DRAINAGE INFORMATION SHEET

RE: DRAINAGE PLAN FOR 524 VERMONT, NE (K-19/D87)
ENGINEER'S STAMP DATED APRIL 12, 1988

524 VERMONT N.E.

DRAINAGE/GRADING PLAN

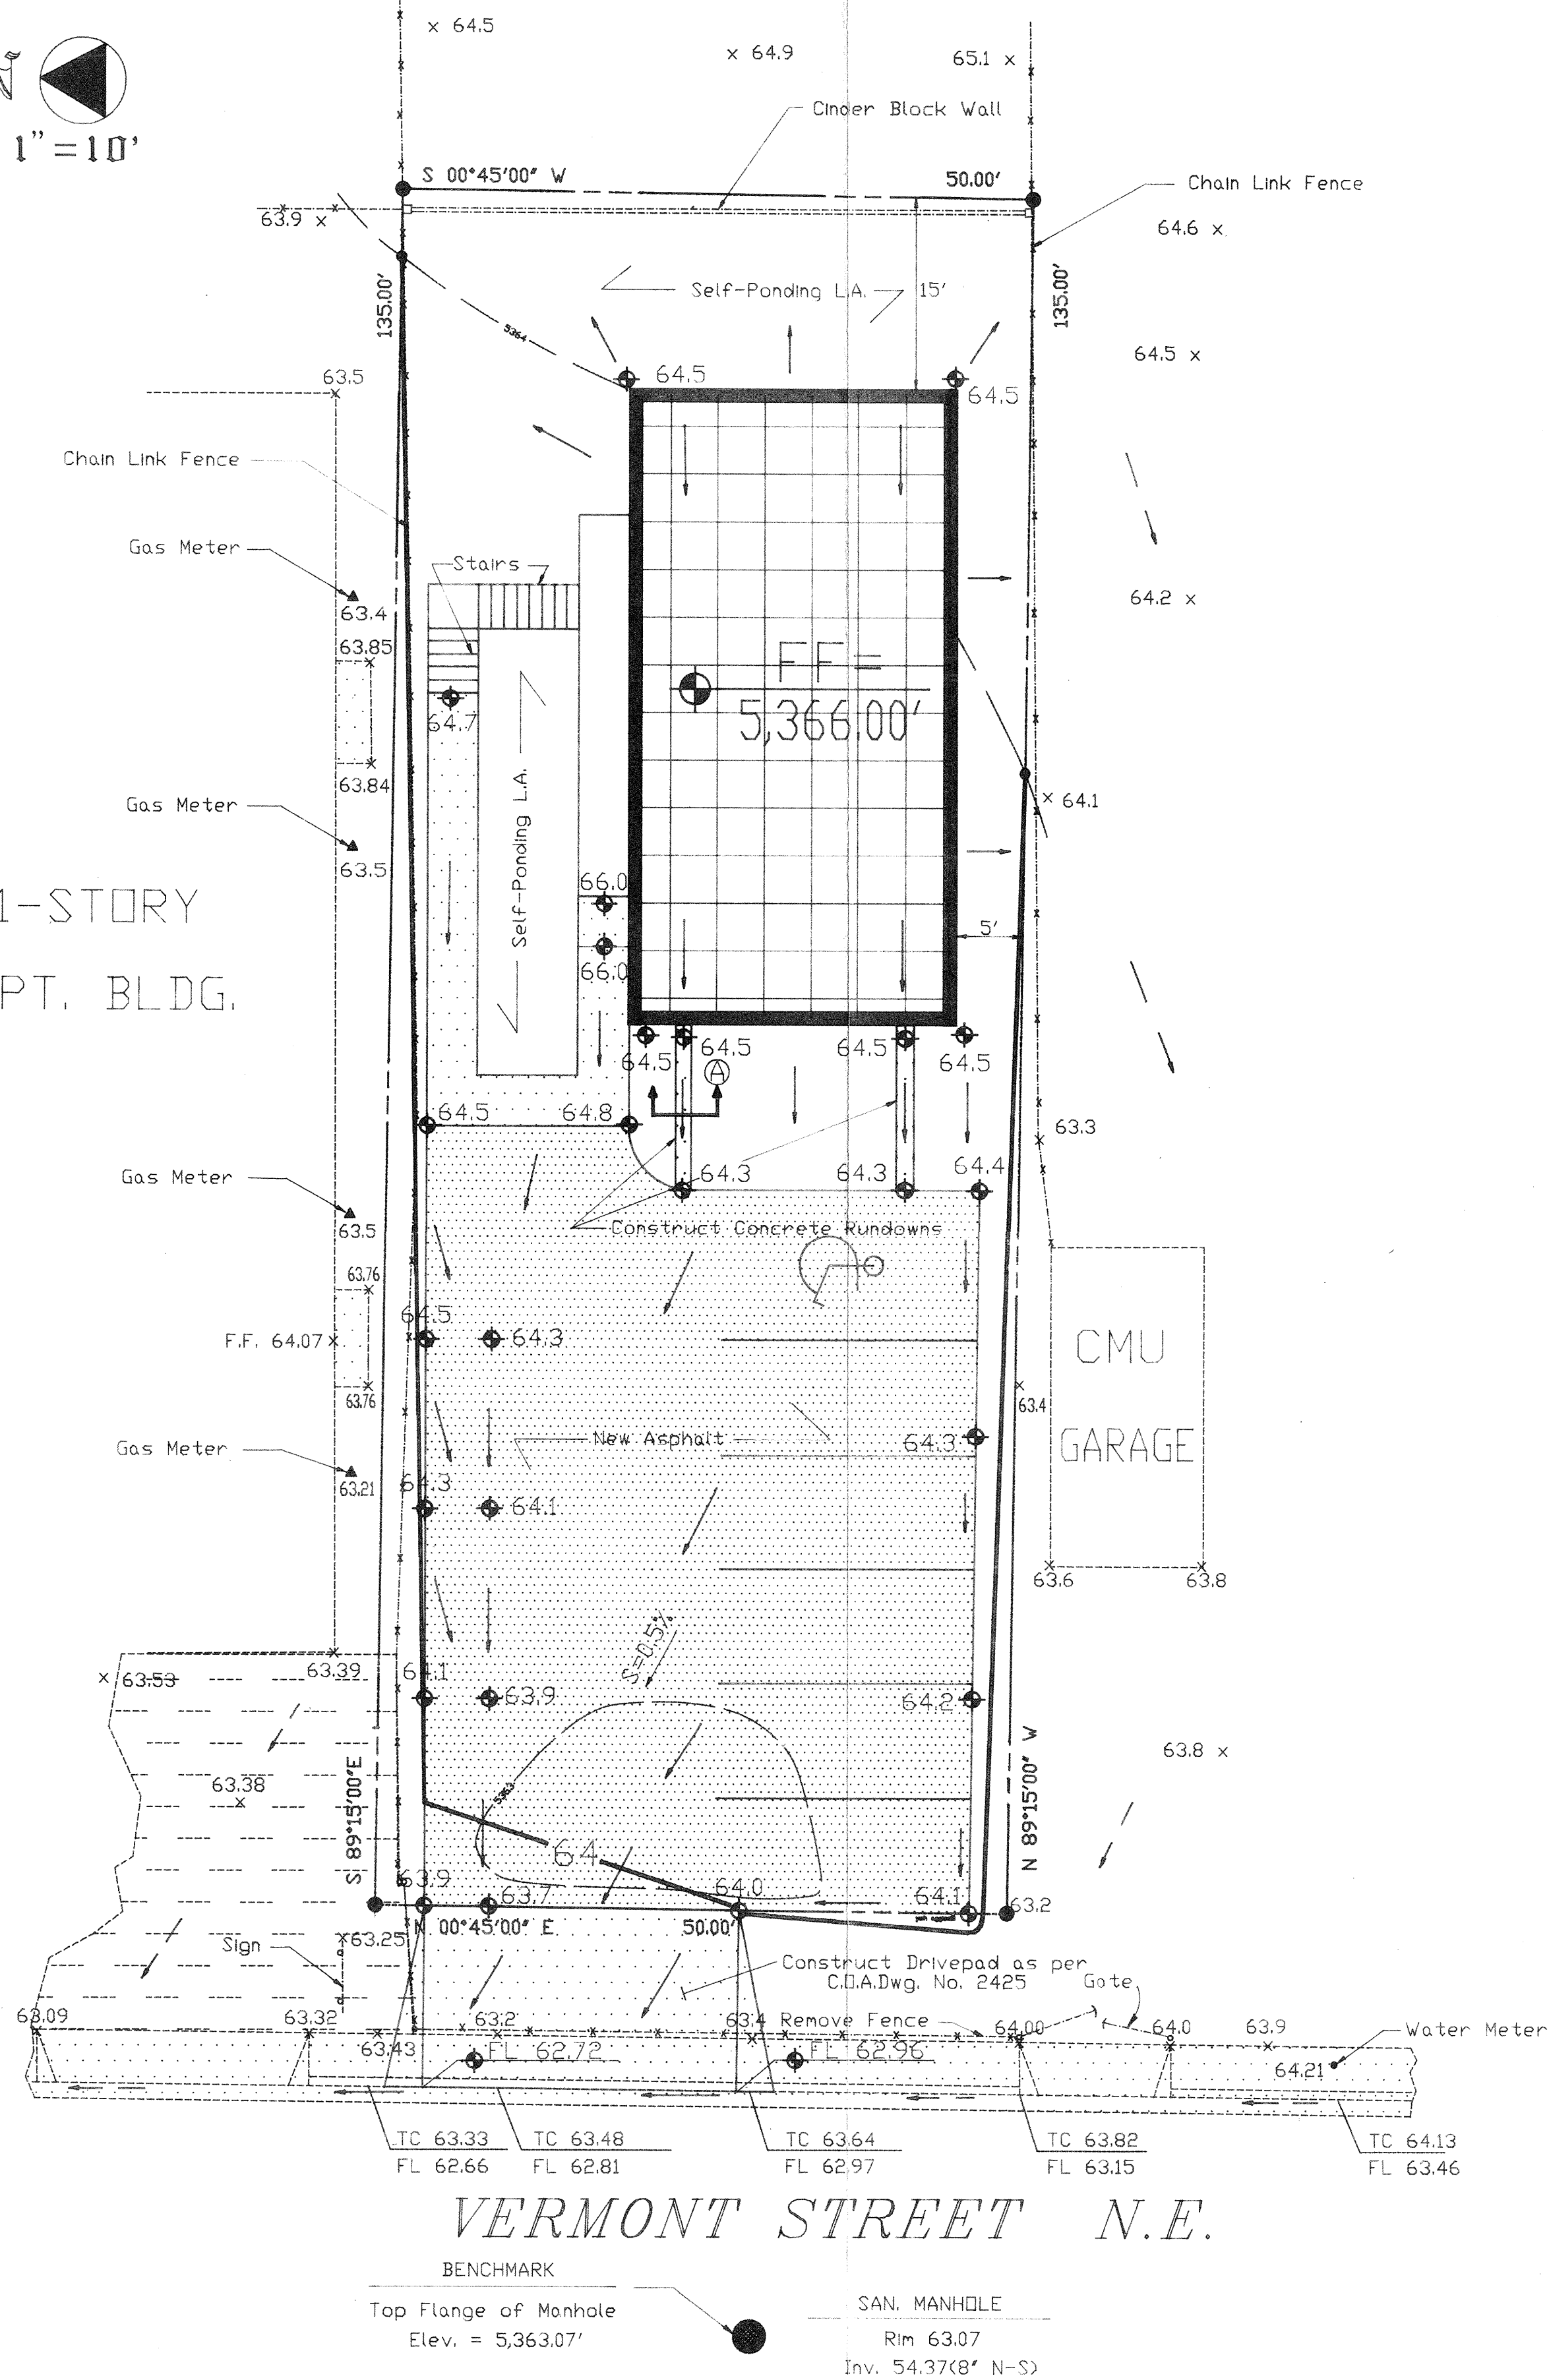
Based on the information provided on your submittal of April 13, 1988, the above referenced plan is approved. Please be advised that no runoff will be allowed to cross the property line.

Please attach a copy of this plan to the construction sets prior to sign-off by Hydrology.

VICINITY MAP K-19

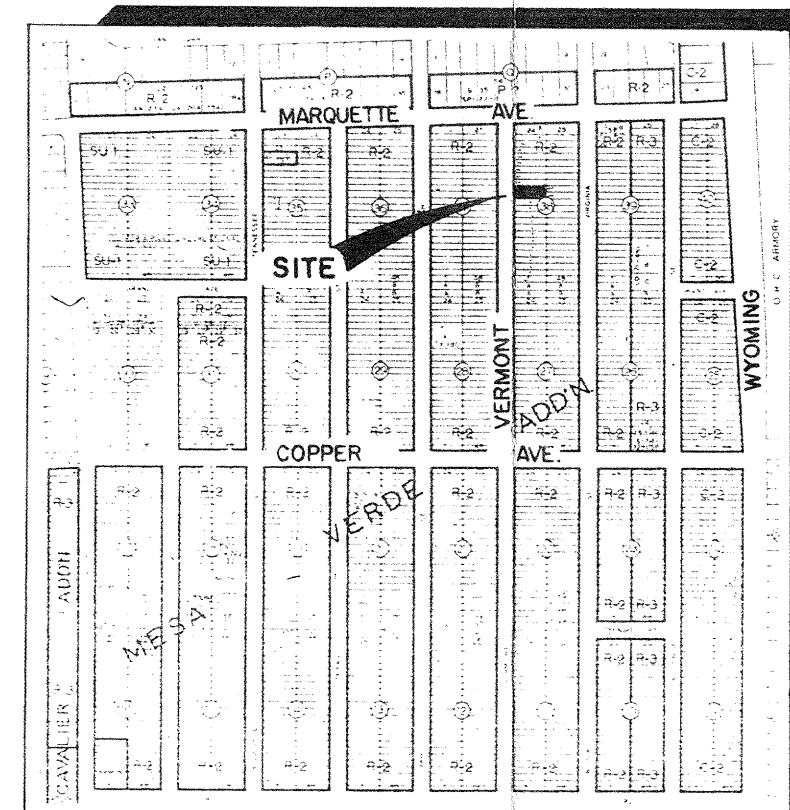
Pre-Design is Lots 13 & 14
of Block 38 - Vicinity Map
indicates lots 14 & 15 as
project site - Information
Sheet says Lot 13A of Block
38
